ADDENDUM NO. 1 - OUTLINE AND SUMMARY INFORMATION

Project Name: Leon Johnson Redundant Heat Pump Module

PPA No.: 19-0042

Date: November 3, 2021

MECHANICAL FLOW DIAGRAMS

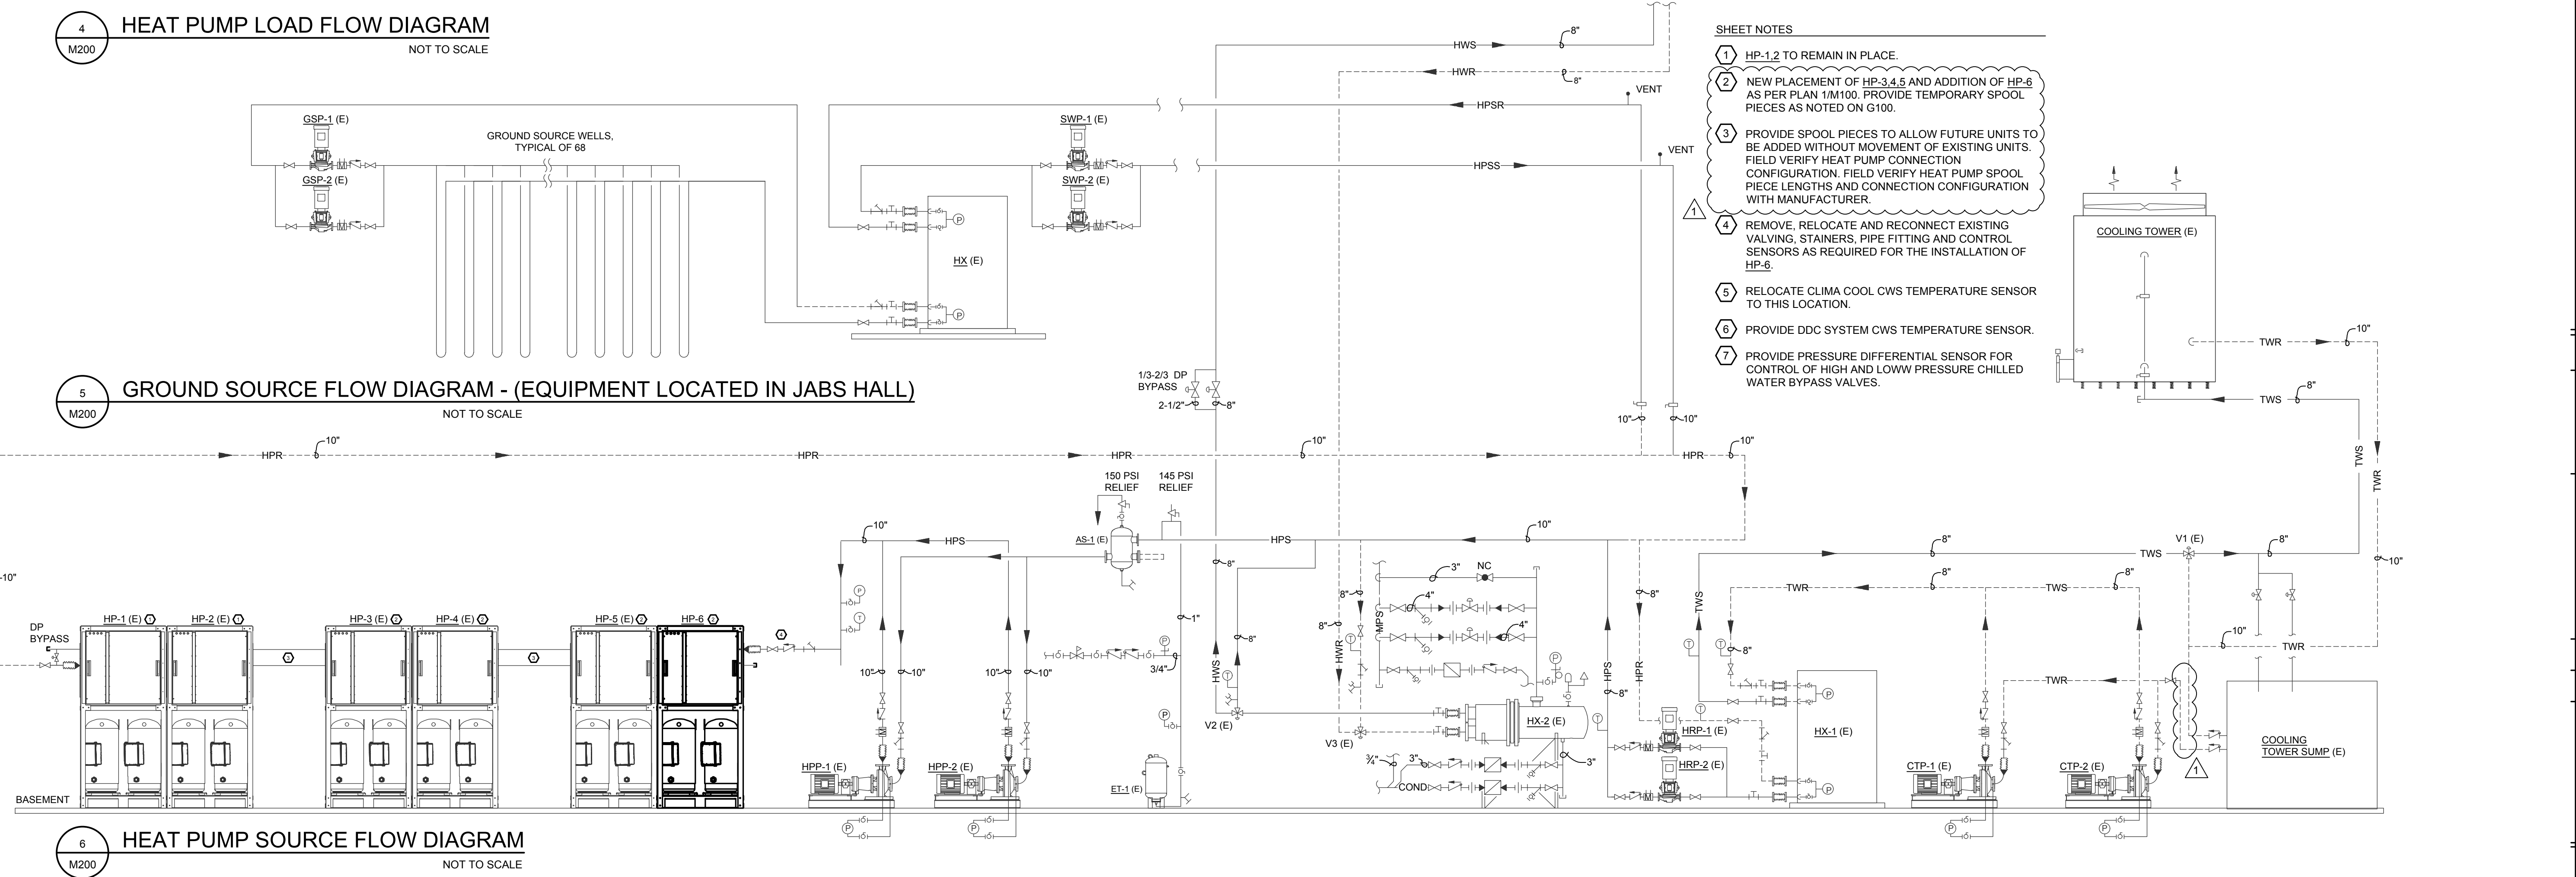
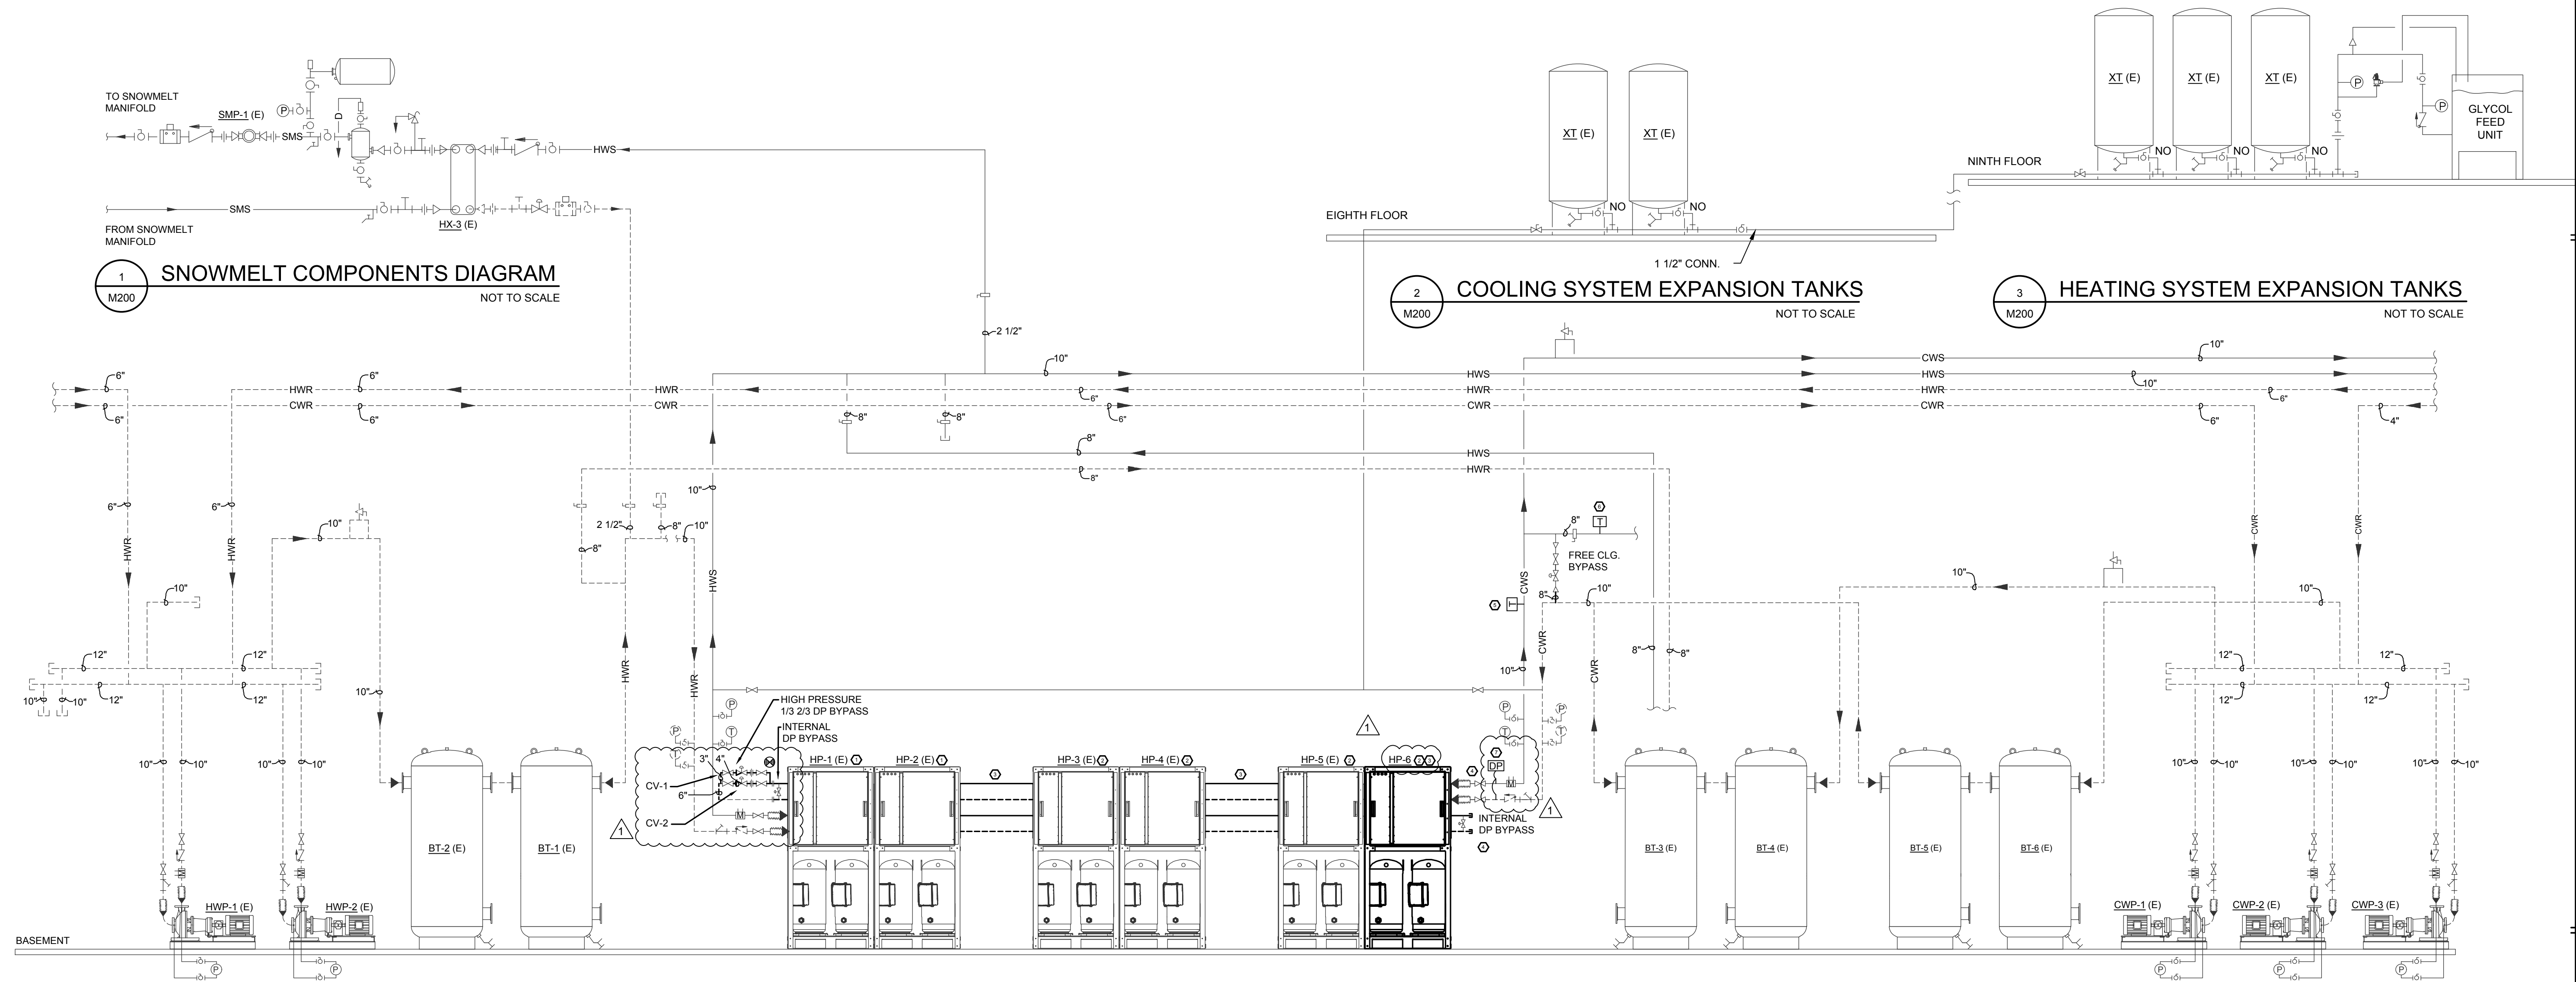
- SHEET NOTES**
- HP-1,2 TO REMAIN IN PLACE.
 - NEW PLACEMENT OF HP-3,4,5 AND ADDITION OF HP-6 AS PER PLAN 1/M100. PROVIDE TEMPORARY SPOOL PIECES AS NOTED ON G100.
 - PROVIDE SPOOL PIECES TO ALLOW FUTURE UNITS TO BE ADDED WITHOUT MOVEMENT OF EXISTING UNITS. FIELD VERIFY HEAT PUMP CONNECTION CONFIGURATION. FIELD VERIFY HEAT PUMP SPOOL PIECE LENGTHS AND CONNECTION CONFIGURATION WITH MANUFACTURER.
 - REMOVE, RELOCATE AND RECONNECT EXISTING VALVING, STAINERS, PIPE FITTING AND CONTROL SENSORS AS REQUIRED FOR THE INSTALLATION OF HP-6.
 - RELOCATE CLIMA COOL CWS TEMPERATURE SENSOR TO THIS LOCATION.
 - PROVIDE DDC SYSTEM CWS TEMPERATURE SENSOR.
 - PROVIDE PRESSURE DIFFERENTIAL SENSOR FOR CONTROL OF HIGH AND LOWW PRESSURE CHILLED WATER BYPASS VALVES.
